PROJECT:	Key West Fire Station #2 (GN1204)	CHANGE ORDER REQUEST NUMBE Thirteen (13)
(Name and address)	616 Simonton St.	DATE OF ISSUANCE: 7/28/2014
	Key West, FL 33040	ARCHITECT'S PROJECT NO.
		CONTRACT FOR: City of Key West
		CONTRACT DATE:
OWNER:	City of Key West	
(Name and address)	3132 Flagler Ave.	
	Key West, FL 33040	
TO ARCHITECT:	mbi k2m Architecture Inc.	CONTRACTOR: D.L. Porter Constructors, Inc.
(Name and address)	1001 Whitehead St.	(Name and address) 6574 Palmer Park Circle
	Key West, FL 33040	Sarasota, Fl 34238

FIELD CHANGE DIRECTIVE 008 PROJECT: <u>GN1204 Fire Station #2</u>

You are directed to proceed promptly with the following change(s): Description: **Changes to roofing and plumbing**.

Attachments: Annotated drawing P2.1.3

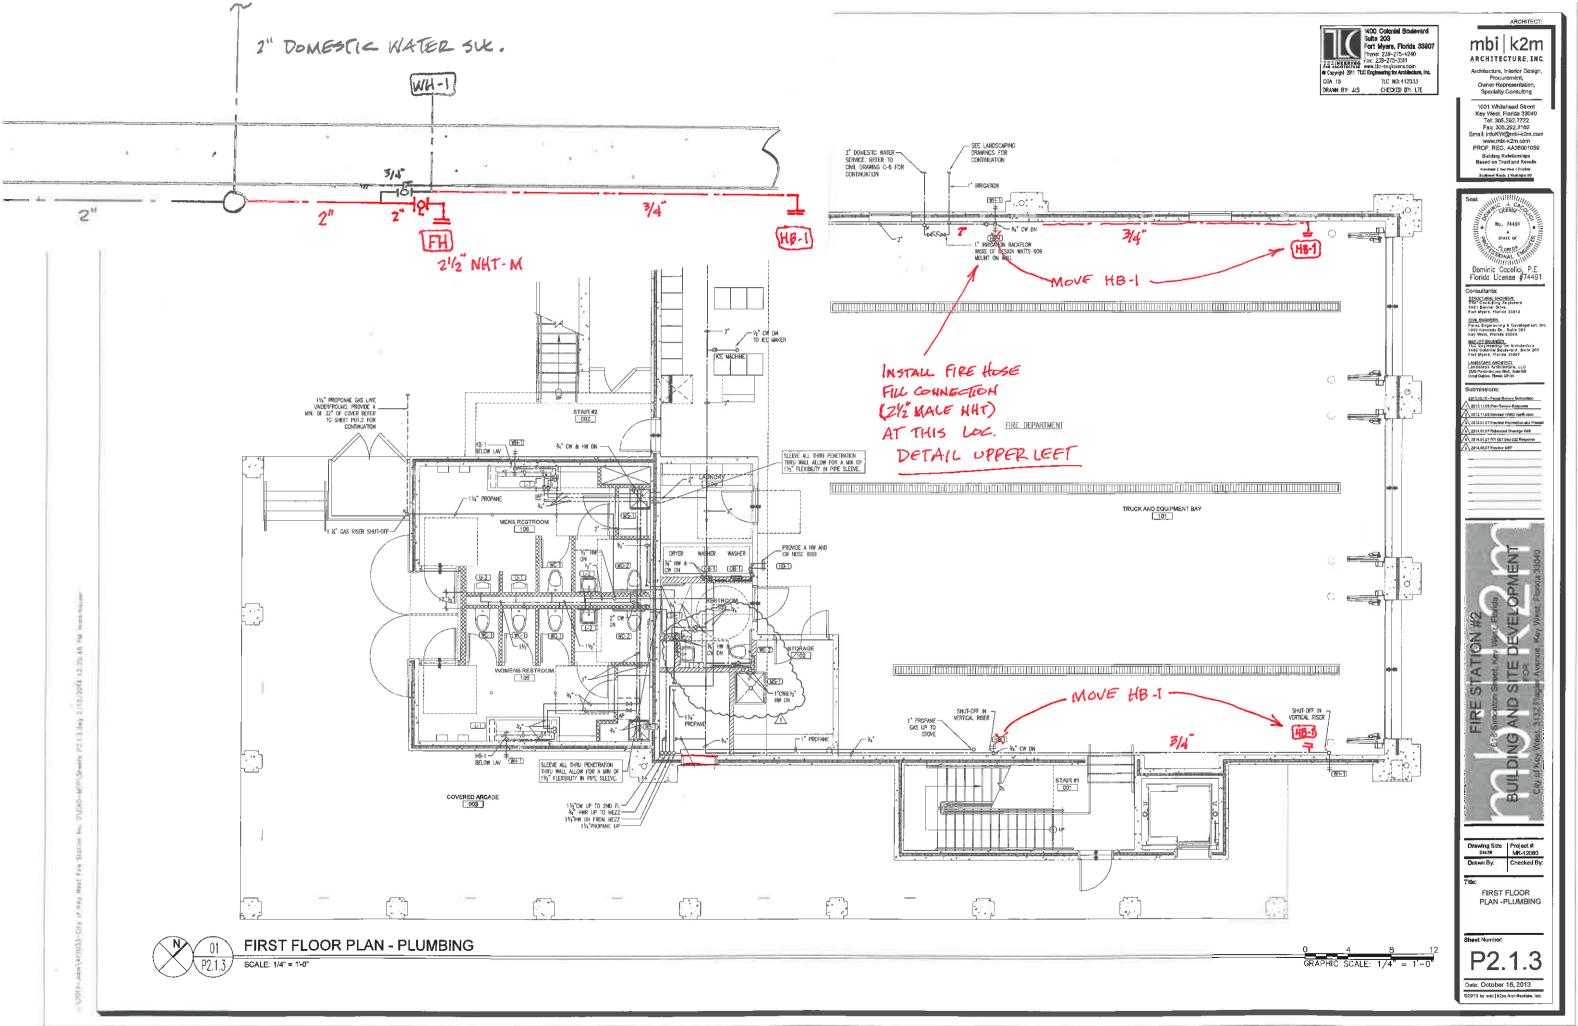
- 1. <u>Add four hanging sewer laterals in the truck bay overhead such that all through-floor drains can</u> be routed within the vertical fins of the double-T flooring system. This is preferred since the vertical fins cannot be laterally drilled. (Reference RFI#49)
- 2. <u>Relocated two hose bibs in the truck bay from the center of the side walls to locations near the</u> exterior bay doors. This modification was requested by KWFD.
- **3.** Provide a 2¹/2" NHT male threaded fitting with shut-off at or near the domestic water line entrance. This fitting is for filling fire truck water tanks as requested by KWFD.
- 4. Install flashing reglet on exterior wall at arcade roof connection. (Reference RFI#48)
